***KING'S MARK
ENVIRONMENTAL REVIEW TEAM
REPORT***

**LAUREL WOODS
SUBDIVISION
SOUTHBURY, CONNECTICUT**

Environmental Review Team Report

**for the
Southbury Inland Wetlands Agency**

LOT LAYOUT

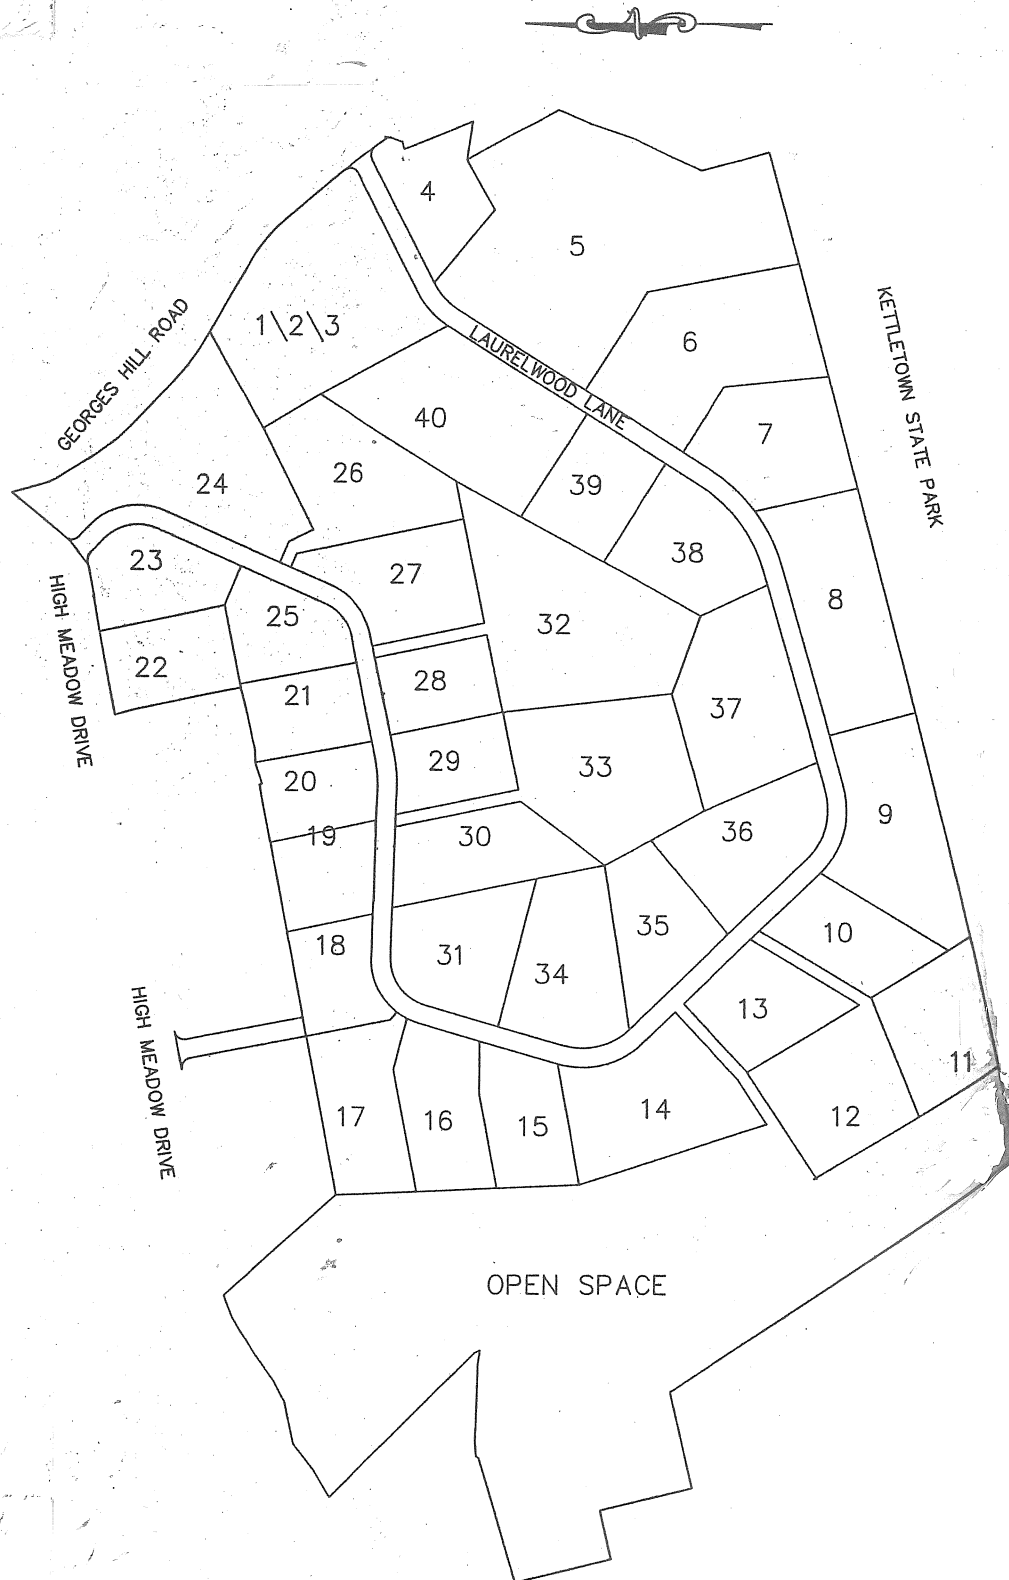
6. Many of the proposed driveways are designed for the maximum 12% slope and they involve 2:1 cuts or embankments. This situation is conducive to concentrating water flow and accelerating erosion and sedimentation. This problem needs to be addressed. Again, the steep slopes will need slope protection. The driveways to interior lots 11 and 12 and lot 32 are examples that present concern.

9. The location of the primary septic system for lot 27 is within 20 feet of a proposed 2:1 downhill slope leading to the driveway of lot 26. The possibility of the septic system contributing to slope failure and pollution is a concern that should be mentioned. This area includes steep slopes, close to bedrock soils or soils with perched water tables as indicated by mottling within 18" of the surface.
